Preliminary Consultation
MONTGOMERY COUNTY HISTORIC PRESERVATION COMMISSION
STAFF REPORT

Address:	707 New York Avenue, Takoma Park	Meeting Date:	3/11/2026
Resource:	Non-Contributing Resource Takoma Park Historic District	Report Date:	3/4/2026
Applicant:	Mark Hishmeh, Ace Construction LLC (Ben Norkin, Architect)	Public Notice:	2/25/2026
Review:	2 nd Preliminary Consultation	Tax Credit:	No
Permit No.:	1143852	Staff:	Laura DiPasquale
Proposal:	Demolition of existing house, tree removal, and construction of new house

Figure 4: Proposed site plan showing the existing and proposed building footprints.

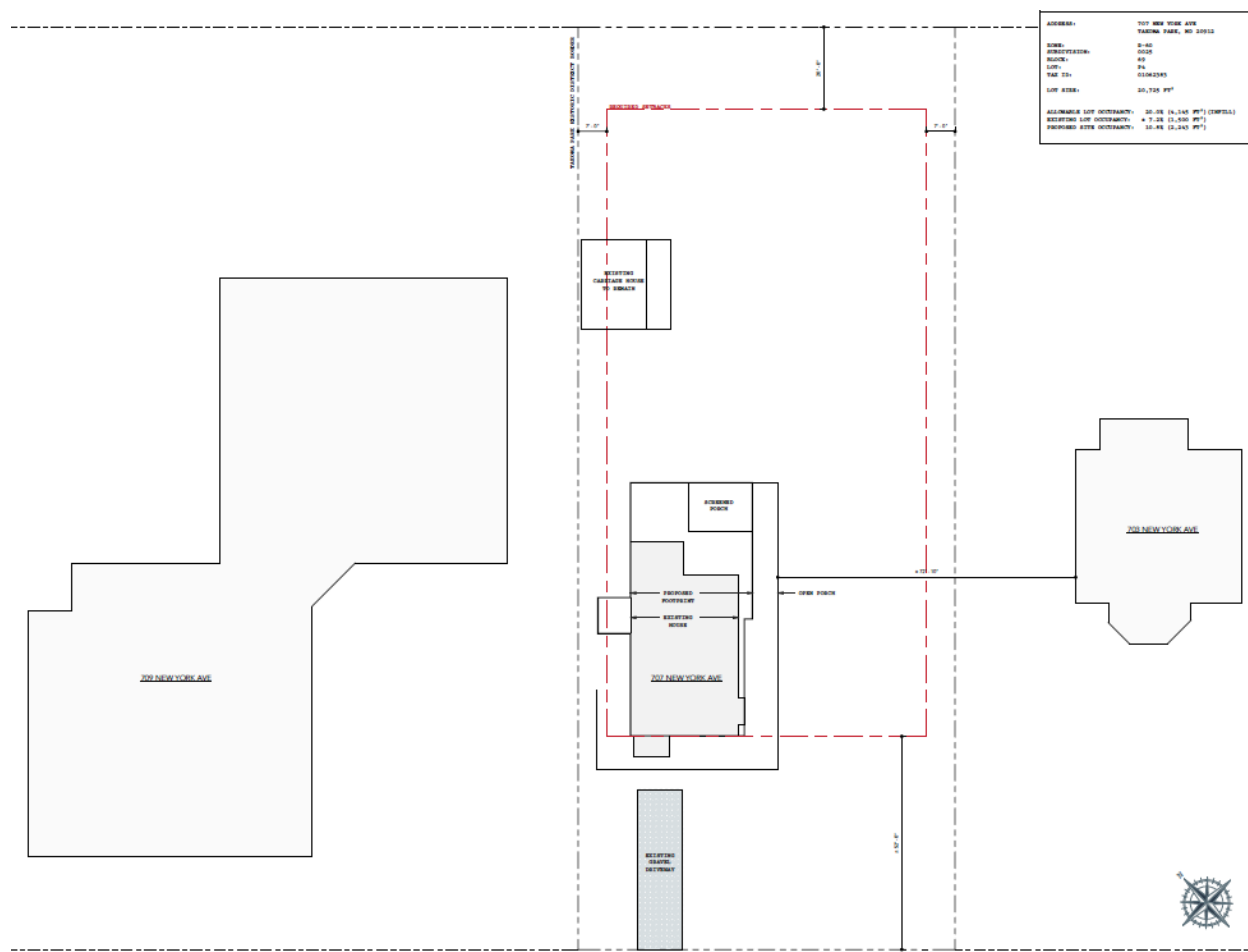
Staff finds that the proposed house respects the existing patterns of building coverage and sense of open space, and that the overall form, massing, and materials of the proposed house, which features a front-gabled roof with large shed dormers on the side elevations, a principal façade oriented towards the street, and a large wrap-around covered porch, is generally compatible with the Takoma Park Historic District and consistent with the recommendations for new construction in the *Guidelines*, but that some additional finessing of floor heights, porch details, and fenestration, particularly at the first-floor front, is still necessary.

At 28 feet in width by 62 feet in depth on a 60-ft wide by 225-ft deep lot with a proposed 52-ft setback from the public right-of-way, staff finds that the proposed size and location of the house on the lot is appropriate and consistent with the general setbacks and size of houses in the district. Staff notes that, while the front wall plane of the proposed house will be positioned approximately 20 feet forward of the Outstanding resource on the adjacent lot at 703 New York Avenue (*Figure 2, Figure 4, Figure 8, Figure 9*), the proposed setback of 52 feet is still generally consistent with the setbacks of larger houses in the district (*Figure 7*), and that the building coverage maintains an ample front and backyard, as well as spacing to the neighboring historic property, per the *Guidelines*.

Figure 6: The previously-proposed conceptual site plan and massing rendering reviewed at the January 7, 2026 HPC meeting.

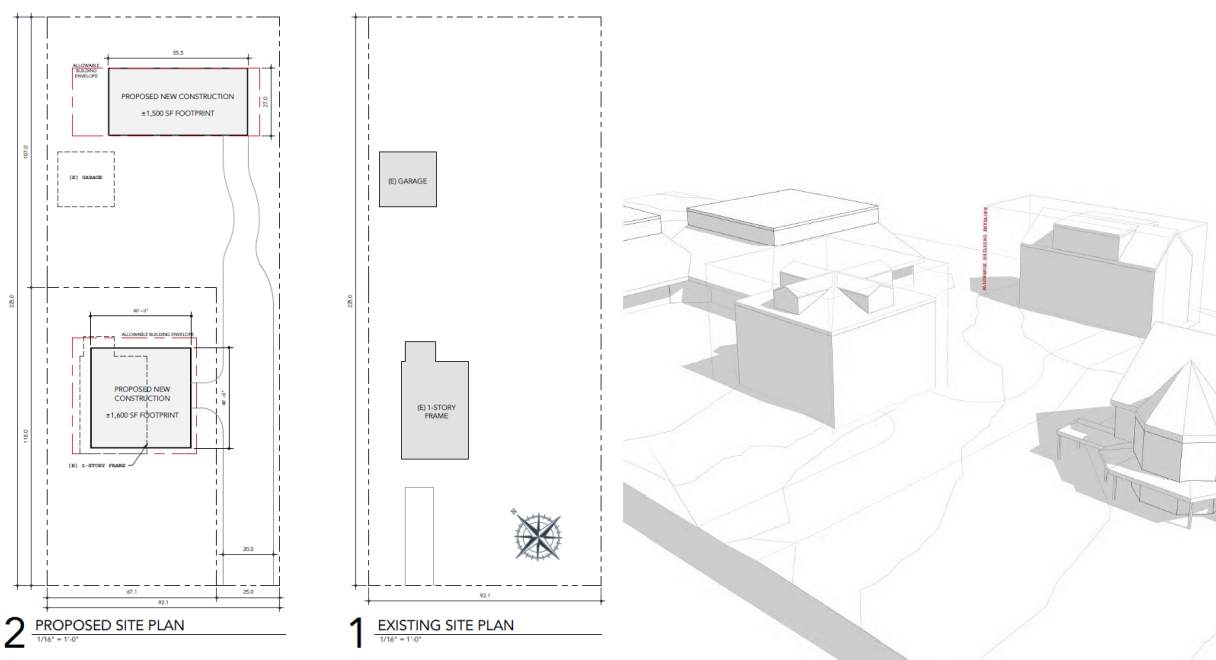
At that meeting, HPC generally concurred with the staff findings and recommended a comprehensive reconsideration of the proposal, with the following general comments:

- The demolition of the Non-Contributing house and garage should be permitted.
- The subdivision itself is of concern primarily owing to the new construction and the shared driveway.

- The proposed subdivision and size, scale and placement of the new construction is not in compliance with the historic development patterns, existing patterns of building coverage, sense of open space, presence of large mature trees, and large front and rear yards.

- If there are to be two buildings within the footprint of the existing lot, the larger building should be toward the front of the lot and the smaller toward the rear.

- Rather than subdividing and constructing two large single-family houses, the applicants should consider a duplex in the form of one larger building, or a larger single-family house with a rear Accessory Dwelling Unit (ADU).

- A 20-foot wide driveway is inappropriate in the district, particularly as proposed alongside the property line shared with an Outstanding resource.
- The design of the building(s) and paving should take into consideration the impact of the design to the district and context.

- The preservation of large, mature trees on the lot is important. If trees cannot be preserved, a replanting condition will be added.

Figure 13: Front elevation of the proposed house.

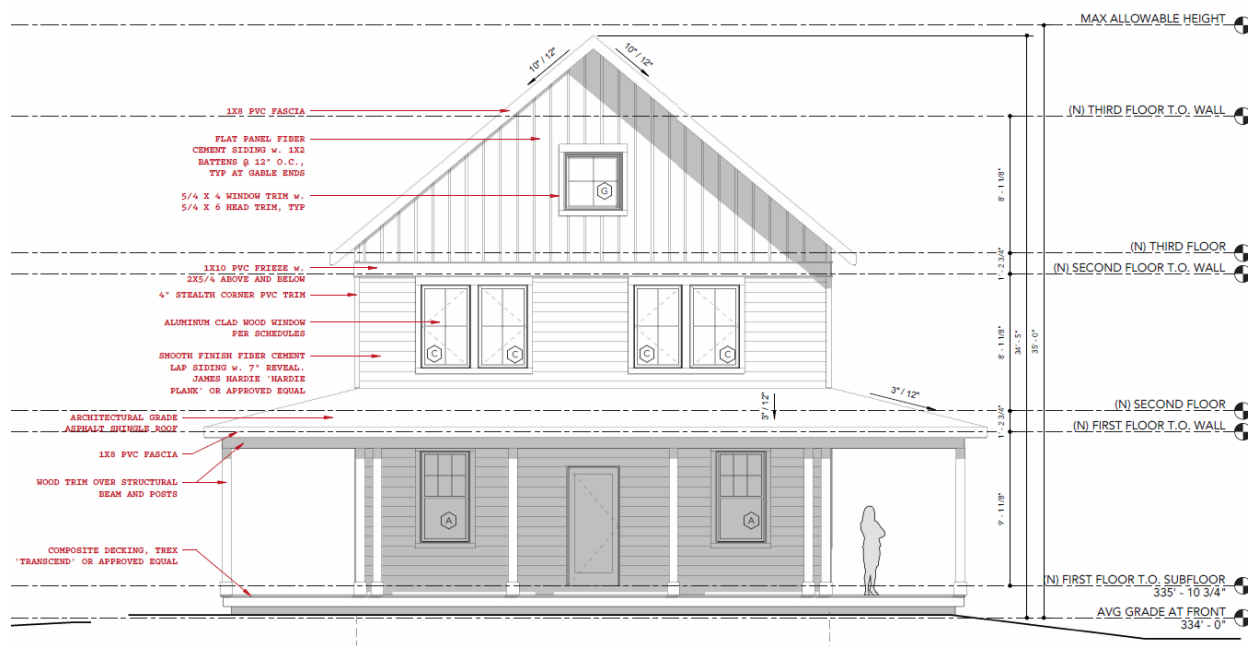
As submitted, the proposed design features a large porch that wraps around portions of all four sides of the proposed house, and a variety of fenestration styles. Staff recommends that the applicants consider hierarchy in their fenestration dimensions and patterns, and reconsider the fenestration of the first-floor front elevation. Staff notes that in traditional building types, such as those found throughout the district, window sizes typically decrease as the building ascends. As submitted, the height and widths of the most windows on all three floors are identical, although the window types differ between the first floor and upper floors, with six-over-one double-hung windows proposed at the first floor and four-light casements proposed for the majority of the second and third floor windows. Staff finds that the smaller panes and meeting rail shadow lines of the proposed double-hung windows, as well as the use of individual punched openings on the first-floor front elevation further decreases the visual scale of the first-floor windows in comparison to the upper-floor windows, which as four-light casements will have a flatter and more vertical appearance.

Additionally, staff finds that the first floor-front elevation, which features a single central door flanked by widely-spaced single double-hung windows, is out of balance. Staff suggests that the first-floor fenestration size be increased, the third-floor window size be decreased, and additional and modified fenestration be added to the first-floor front elevation. For example, staff finds that the applicants could consider shifting the entry door to the left bay and adding a triple ganged window to the right, or adding sidelights and a transom to enhance the front entry door.

Regarding the wrap-around porch, while staff finds porches extending the full width of the front façade and/or wrapping around one side of a house are common in the district, a porch wrapping all four sides of the house, as proposed, is unusual. Staff does not find that the proposed porch would detract from the character of the district, necessarily, but suggests the applicants evaluate the extent of the porch along the southeast side elevation and consider breaking the porch into separate pieces and allowing a portion of the side plane of the house to be exposed. Staff also recommends adding a stair or railing to the front porch to distinguish the front entry and adding additional detailing and size to the proposed porch columns.

Figure 16: Proposed site plan and tree survey showing the existing trees and proposed tree removal. The trees proposed for removal are shown in green and are highlighted by red arrows.

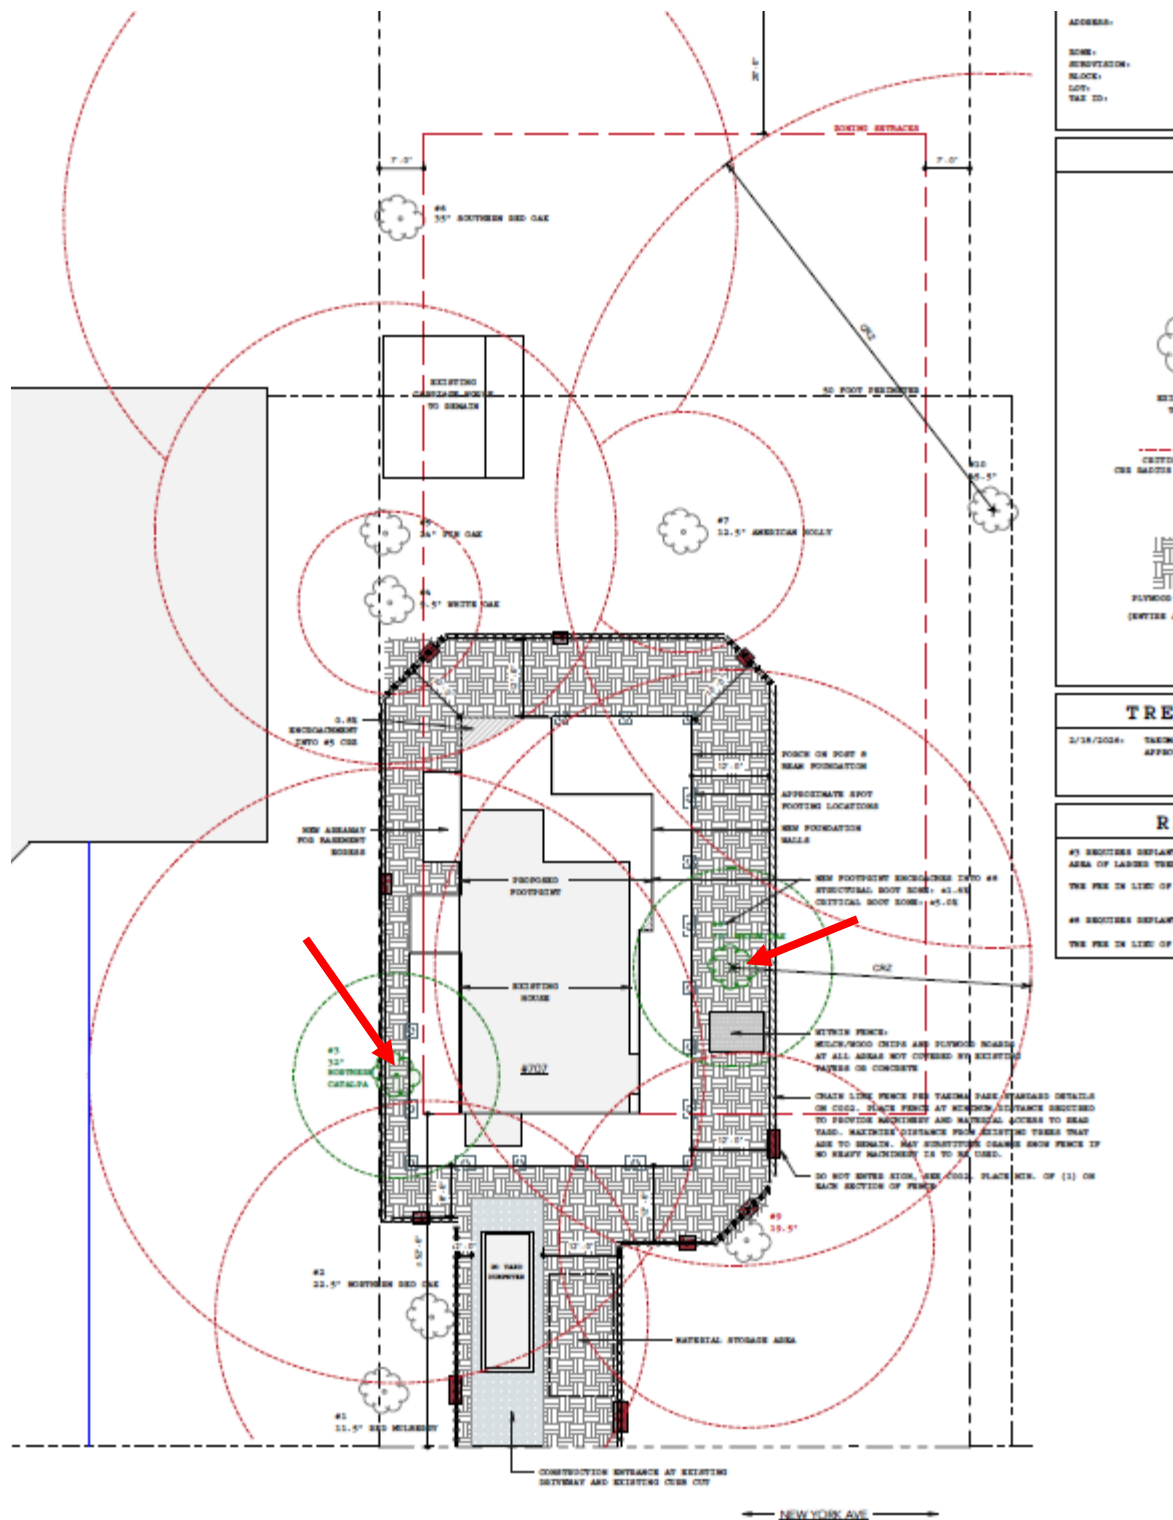
added. Staff finds that the applicants have taken some steps to preserve at least one additional tree on site, but recommends that tree #8, the Northern Catalpa be retained, with the potential to shift the building footprint away from the tree, provided it will not result in damage to additional trees. Staff recommends that the HPC allow the removal of tree #3, conditional upon the replanting of a minimum of two large-species canopy trees in the front or side yard of the property, and that a replanting plan be included with submission of the HAWP. Staff notes that two large canopy trees were found to be dead or hazardous in fall 2025 and have already been removed from the property without any succession planting, and that the additional removal will result in significant loss of tree canopy in the district.
